# F.R. Berry & Associates

Our Ref. **2045**

**RE: PARKING AND SIDEWALK PROVISIONS  
SILVERLEAF SUBDIVISION, LONDON**

**URBAN LOCAL ROAD  
CROSS-SECTION**

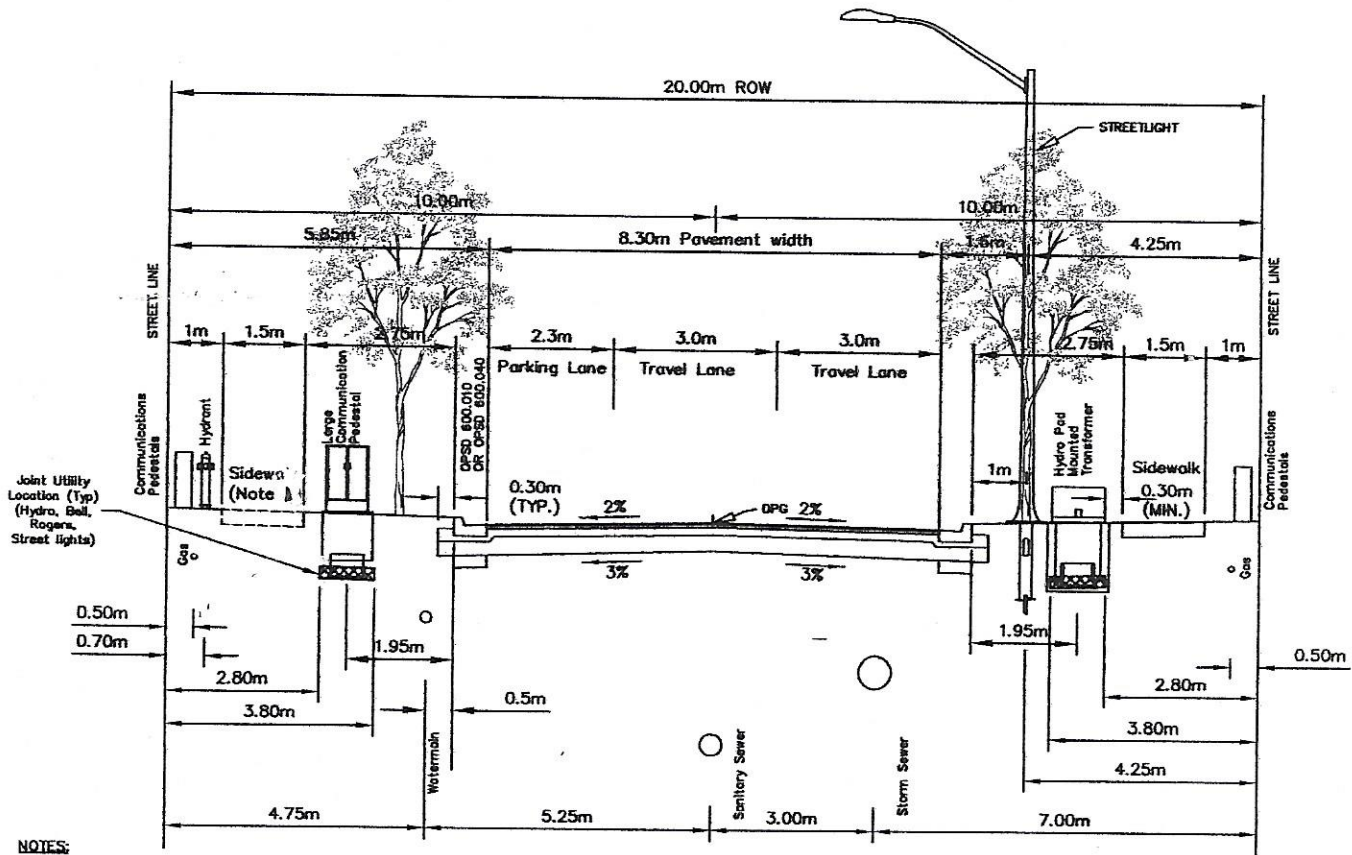
I have attached a typical cross-section for an urban local road. This happens to be from the City of St. Thomas Design Guidelines Manual but is representative of best practices in the industry. It is supported by recommendations and guidelines in the Transportation Association of Canada (TAC) urban Supplement to the Geometric Design Guide for Canadian Roads.

A parking lane in addition to two traffic lanes is, in my opinion, mandatory for local streets except on cul-de-sacs or looped streets less than 150 metres in length where traffic volumes are very low. A parking lane is necessary to accommodate visitors and service vehicles and also to provide additional space when street repairs or maintenance is required.

The attached cross-section indicates that a sidewalk on one side only is required in most cases. Sidewalks on both sides would be justified for reasons of connectivity, such as a school access or commercial development. Neither of these features is present in your subdivision.

At this stage of development, I agree it is impractical to widen the local streets in the Silverleaf subdivision. All the more reason, therefore, to limit sidewalks to one side only. I agree with Mr. Baird's assessment of the current situation and his conclusion that "the only viable solution to the problem is the elimination of the proposed sidewalk on one side of the street".
